## TECHNICAL INFORMATION BULLETIN

**DrivePack DPDA  
Input Module Modification**

NUMBER: TB- 053

DATE: 06/08/2012

**Fig.1 Location of FB19 on middle board**

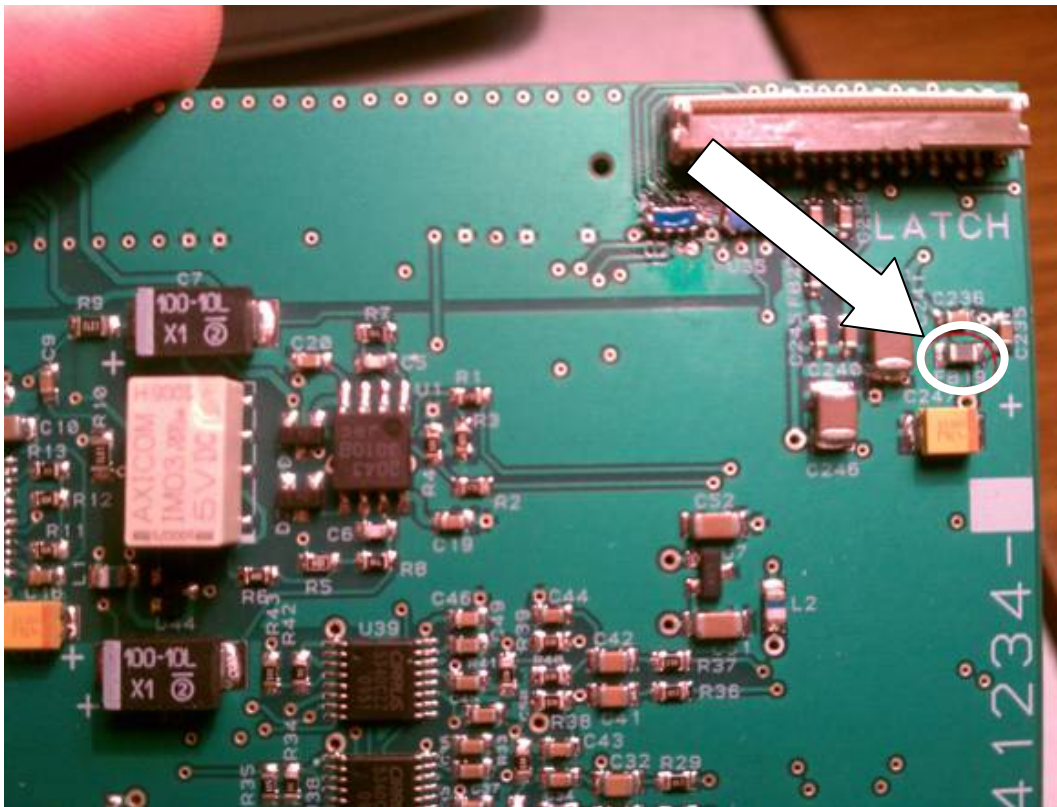
1. Two ferrite beads must be changed on the middle board, versions **PWA 141234-5 or earlier**. Board versions **PWA 141234-6 and newer need not be modified**. They should already have the correct ferrite bead. Change **FB13** for the DSP's +1.3V supply and **FB19** for the D/A convertor's +5V supply. Instructions for this procedure are found under the "Solution Procedure" heading of this document.
2. It is also required to change **R96** on any top board version **PWA 141213-6 or earlier** from 7.68k to **10.5k**. For **PWAs 141213-7 or 141213-8**, **R96** must be changed to **9.76k**. Top board versions **PWA 141213-9 or newer need not be modified**, they should already have the correct value of 9.76k for R96. Instructions for this procedure are found under the "Solution Procedure" heading of this document.

1. Remove the (2) T-15 Torx screws that hold down the top board (PWA-141213).
2. Remove the top board to access the middle board, **PWA 141234-5 or earlier**.
3. Locate FB19 & FB13 on the middle board as indicated in Fig.1 & Fig. 2. Replace FB19 & FB 13 with a higher current part (JBL part number 141686-1JBL).
4. Locate R96 on the top board as indicated in Fig.3. With **PWA 141213-6 or earlier**, replace R96 with 10.5k (Part Number 141212-5jbl). With **PWA 141213-7 or PWA 141213-8**, replace R96 with 9.76k (Part Number 141212-6jbl).
5. Reassemble the input module and test/confirm proper operation.
